H. B. ROBINSON UNIT NO. 2
LICENSE DPR-23
TECHNICAL SPECIFICATIONS' CHANGES

The Company requests changes to the H. B. Robinson Unit No. 2 Technical Specifications with regard to the calibration requirements in Table 4.1-1 of Section 4.0 and organization changes in Section 6.1. Revised pages of figures 6.1-1 (page 6.1-12) and 6.1-2 (page 6.1-13) reflect the requested organization changes.

H. B. ROBINSON UNIT NO. 2
LICENSE DPR-23
TECHNICAL SPECIFICATIONS' CHANGES

Figure 6.1-1
6.1-12

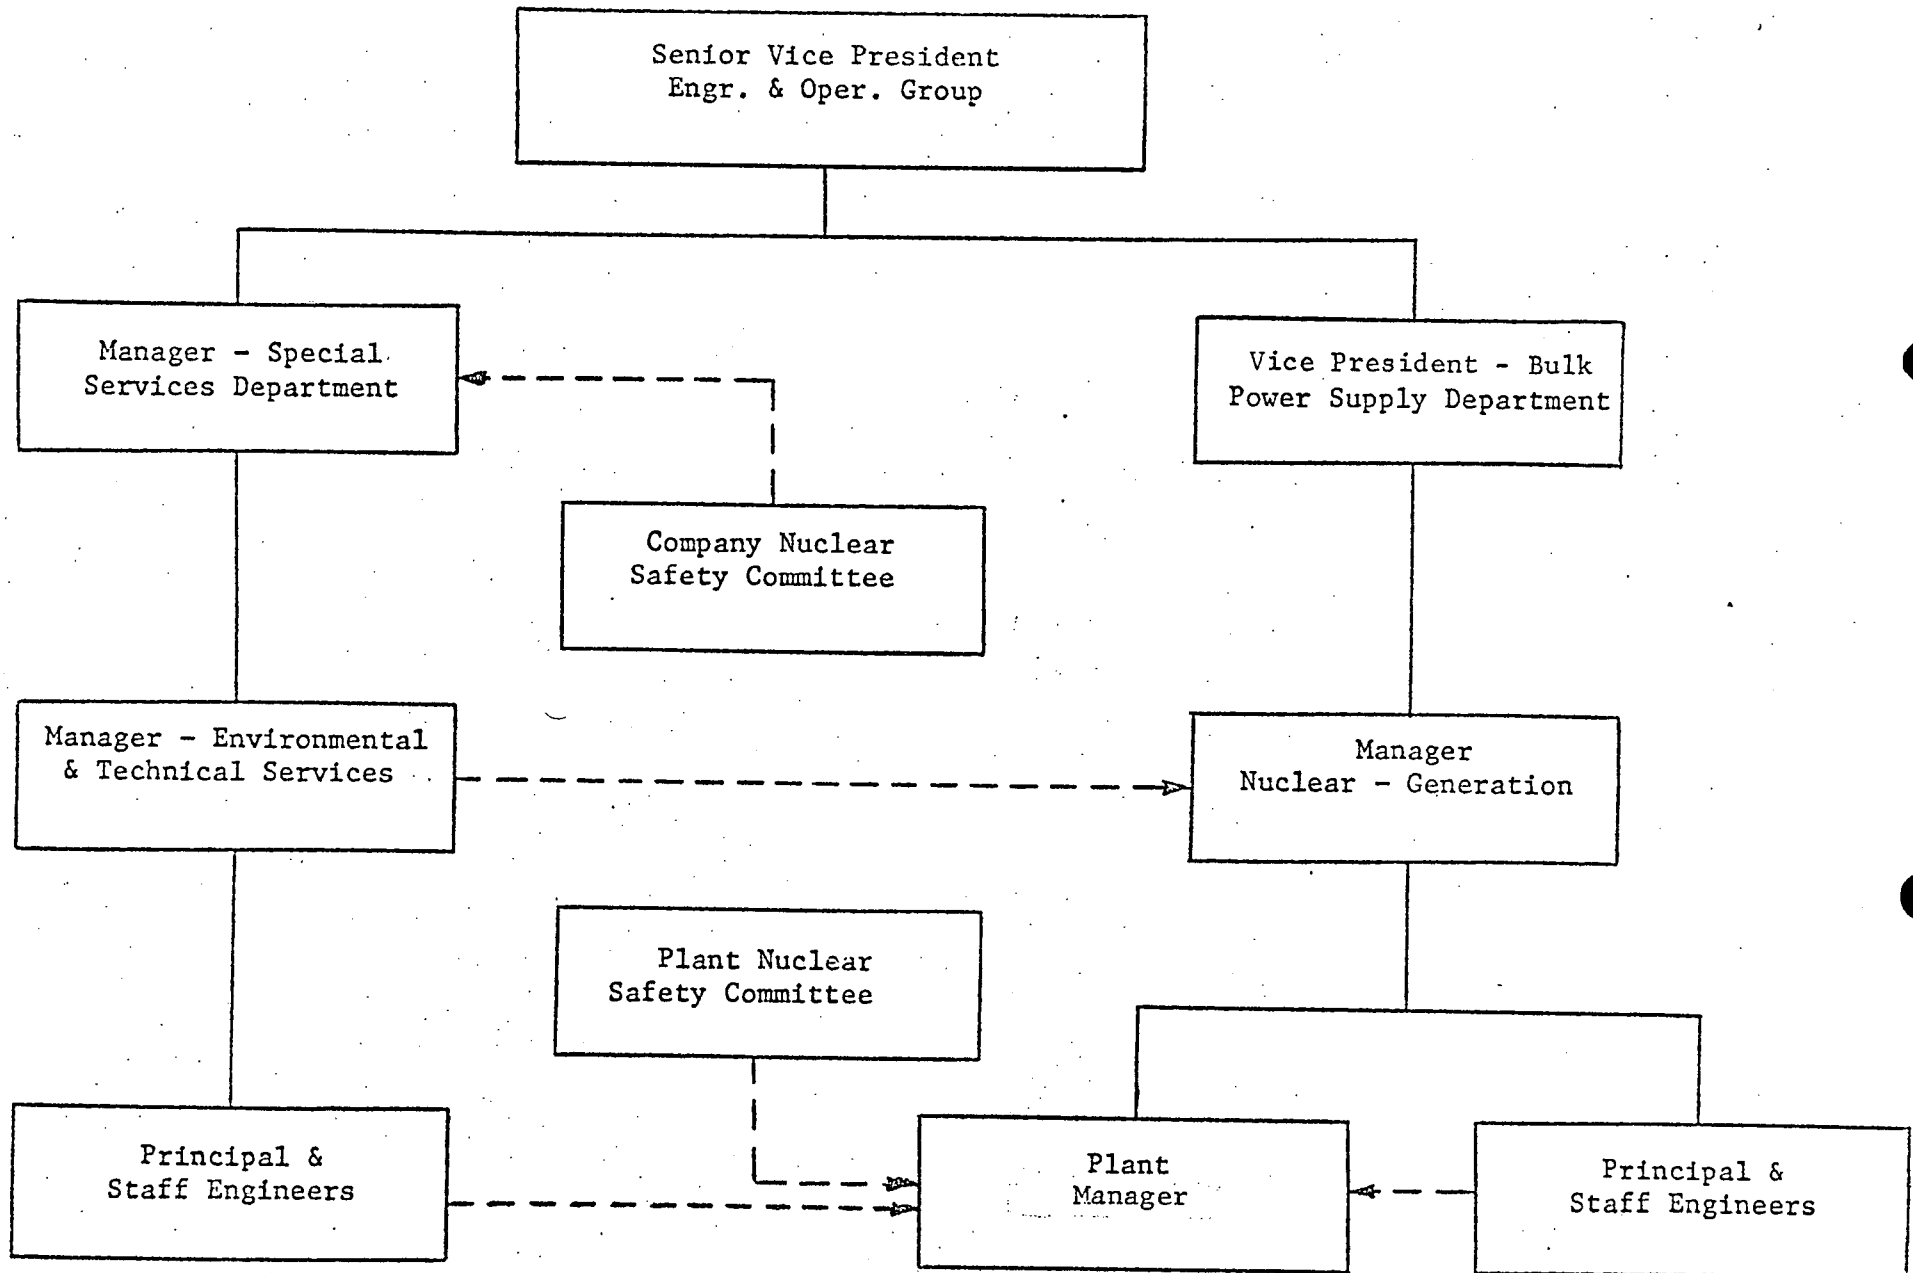
The title of Plant Superintendent has been changed to Plant Manager in all of the Company's steam plants.

Title changes in the Carolina Power & Light Company Organization should be reflected in the Technical Specifications.

Figure 6.1-2
6.1-13

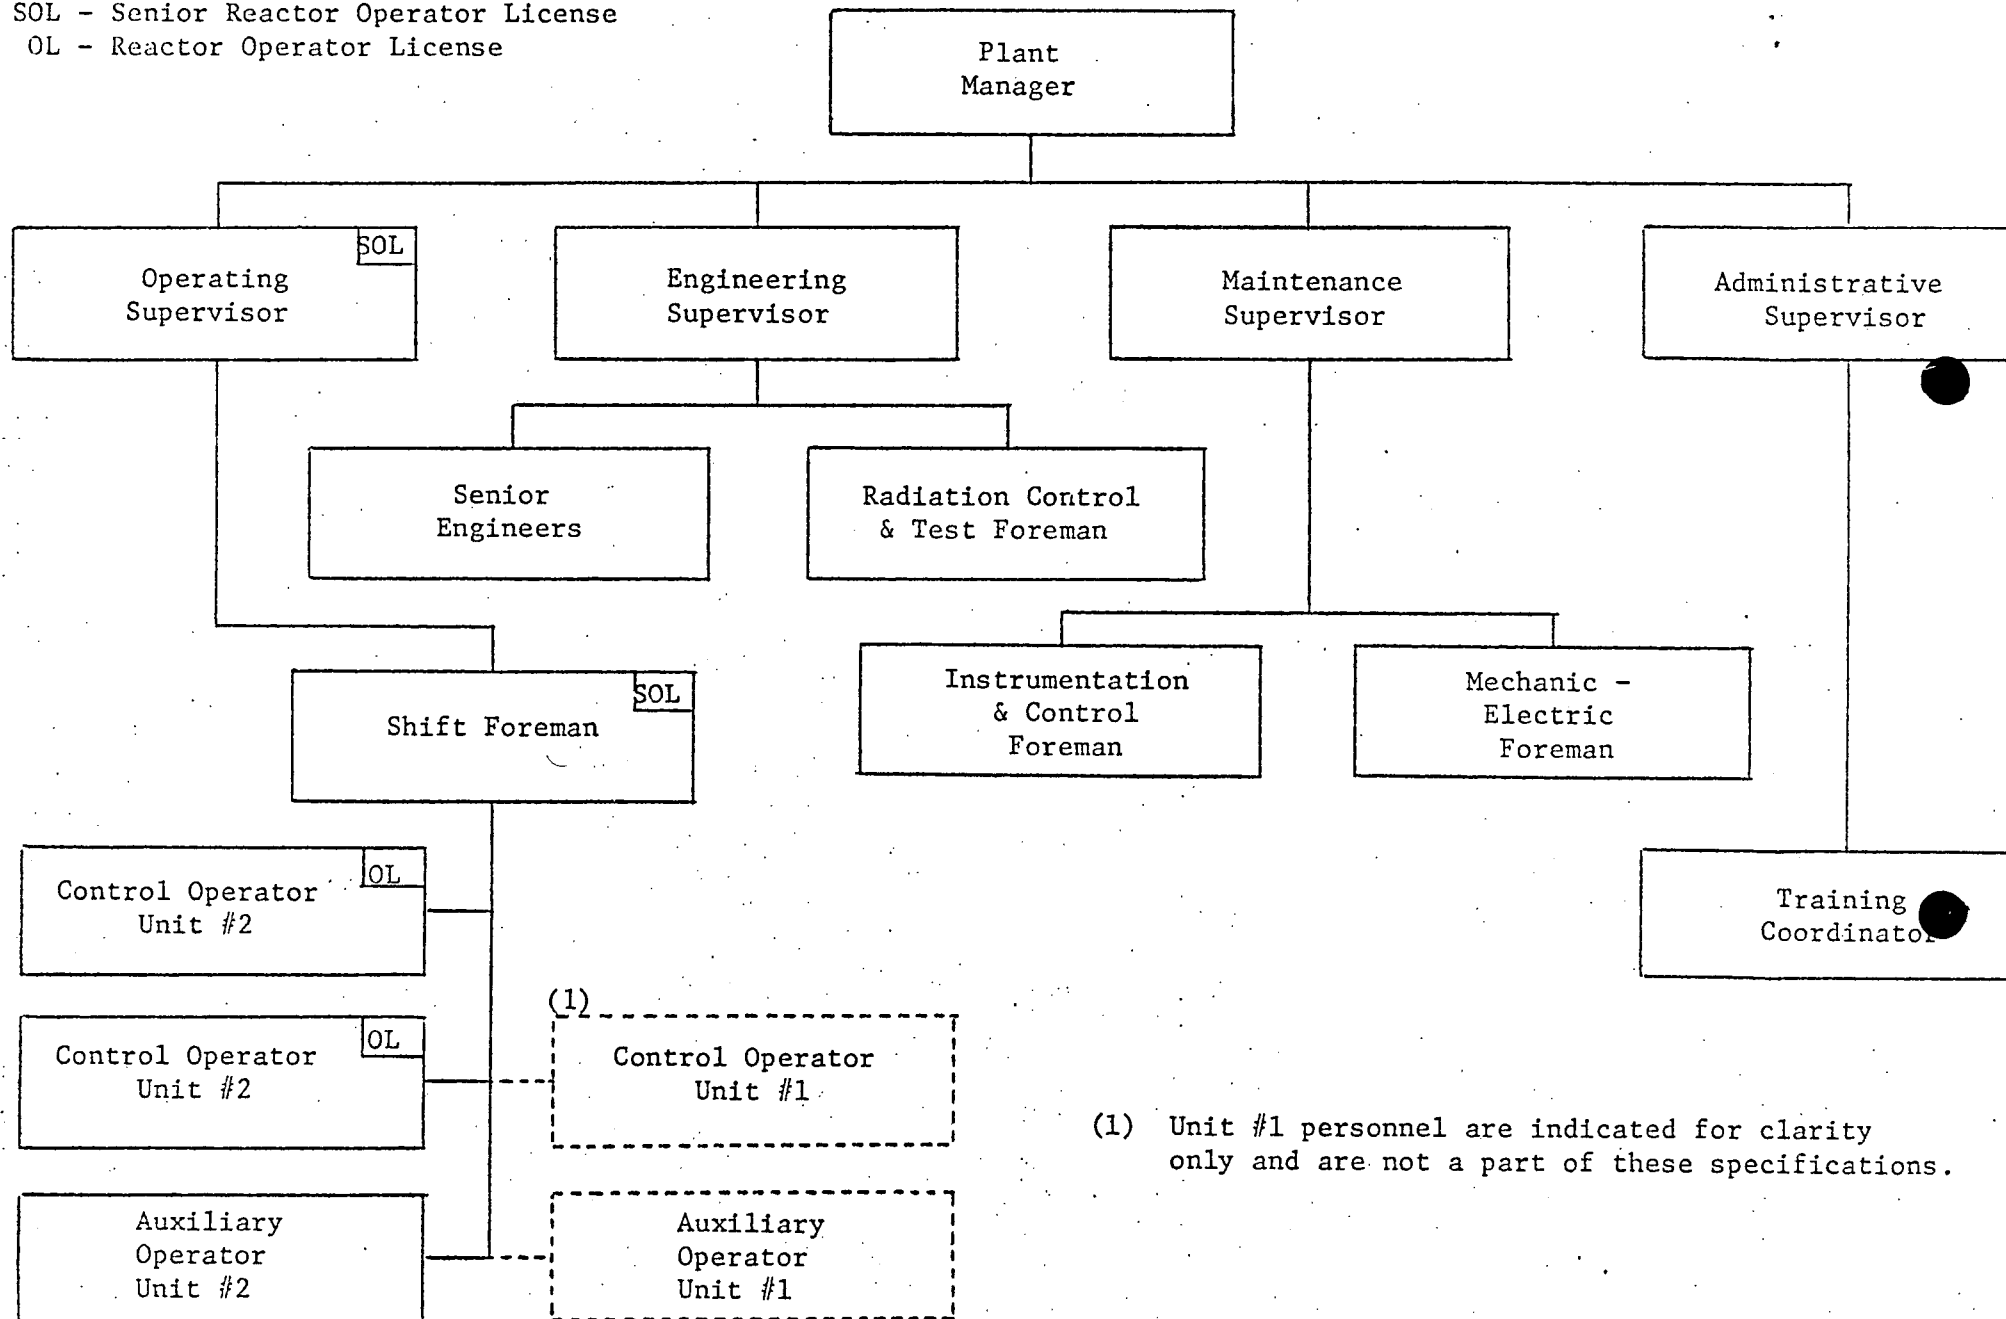
Due to the addition of two positions on the plant staff, insertion of the minimum qualifications for the Administrative Supervisor and the Training Coordinator should be made to this section. Administrative Supervisor should be placed between 6.1.3.1.d Maintenance Supervisor and 6.1.3.1.e Radiation Control and Test Foreman. Training Coordinator should be placed after 6.1.3.1.h Nuclear Engineer.
